UNITED STATES
DEPARTMENT OF THE INTERIOR
BUREAU OF LAND MANAGEMENT

FORM APPROVED
OMB NO. 1004-0135
Expires: July 31, 2010**SUNDRY NOTICES AND REPORTS ON WELLS**
Do not use this form for proposals to drill or to re-enter an abandoned well. Use form 3160-3 (APD) for such proposals.**SUBMIT IN TRIPLICATE - Other instructions on reverse side.**

Endurance 36 State Com 701H
30-025-42984
EOG Resources, Inc
Surface Location: Sec. 36, T. 26S, R. 33E
Conditions of Approval

10-3/4" X 7-5/8" X 5-1/2"
FBD-100 WELLHEAD SYSTEM
QUOTE # - 93482

DRAWING NO
WH-15848

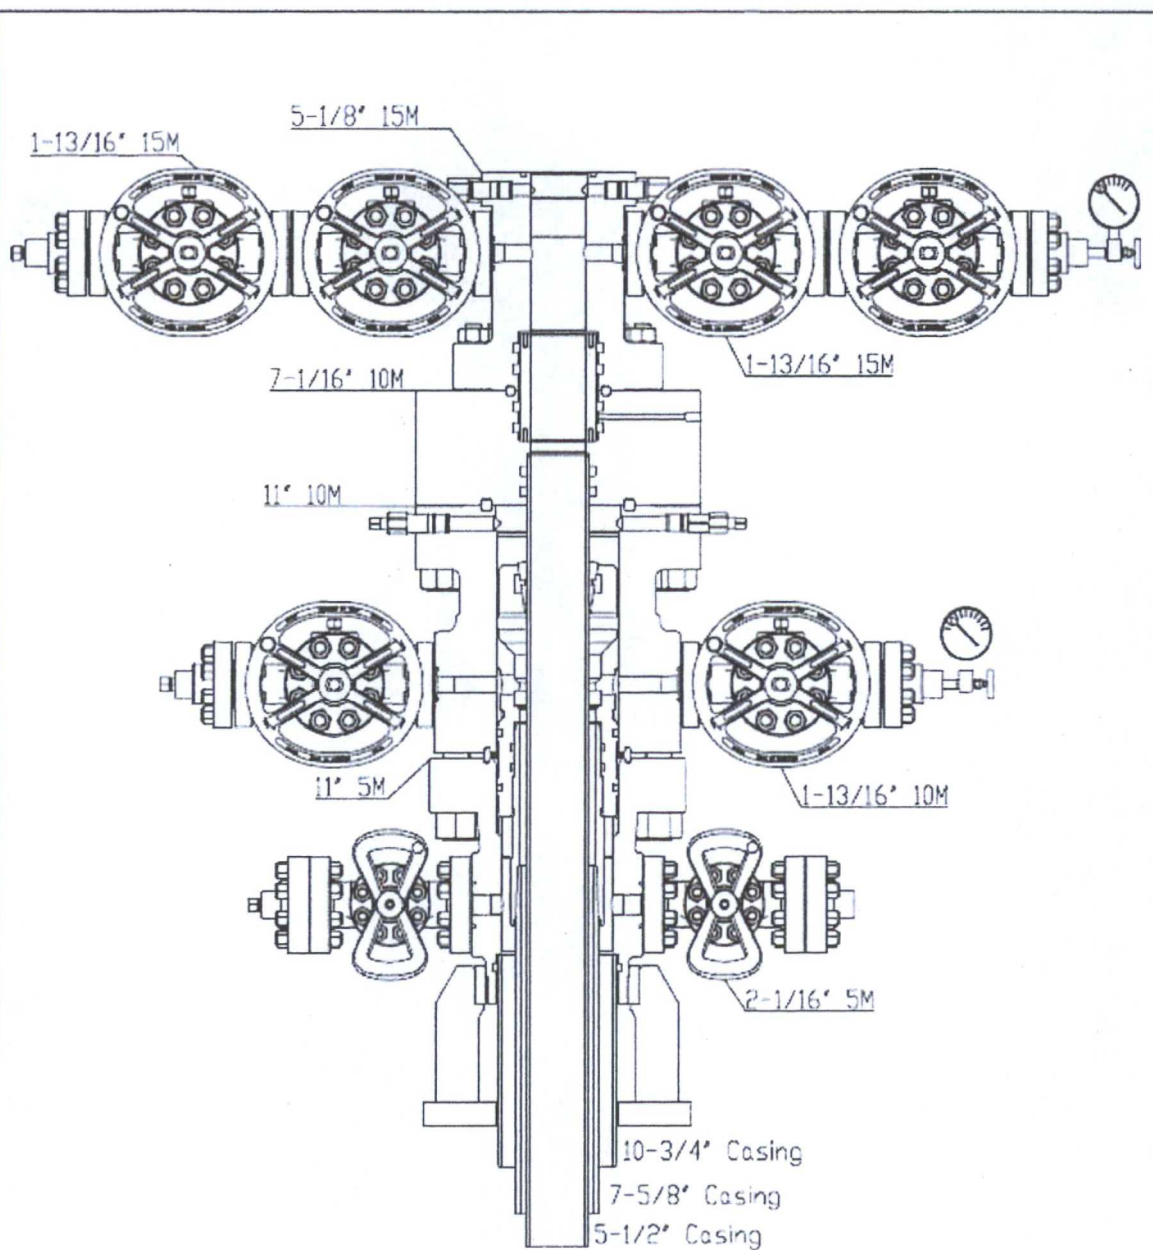
2. Operator has proposed a **multi-bowl wellhead assembly**. This assembly (BOPE/BOPE) will be tested when installed on the surface casing. Minimum working pressure of the blowout preventer (BOP) and related equipment (BOPE) required for drilling below the surface casing shoe shall be **5000 (5M) psi**.

- a. Wellhead shall be installed by manufacturer's representatives, submit documentation with subsequent sundry.
 - b. All BOP equipment will be tested utilizing a conventional test plug. Not a cup or J-packer type.

- c. If the welding is performed by a third party, the manufacturer's representative shall monitor the temperature to verify that it does not exceed the maximum temperature of the seal.

- d. Manufacturer representative shall install the test plug for the initial and all BOP testing.
 - e. **Prior to running the intermediated casing, the rams will be changed out to accommodate the 7-5/8" casing. After installing the intermediate casing the casing rams will be removed and replaced with variable bore rams.**

3. Operator has broken a seal on the BOP stack therefore per Onshore Oil and Gas Order No. 2 **the entire BOP stack shall be tested prior to drilling out the intermediated casing.**

- a. A solid steel body pack-off will be utilized after running & cementing the intermediate casing. After installation of the pack-off and lower flange will be pressure tested to 5000 psi.

- b. If the cement does not circulate and one inch operations would have been possible with a standard wellhead, the well head shall be cut off, cementing operations performed and another wellhead installed.
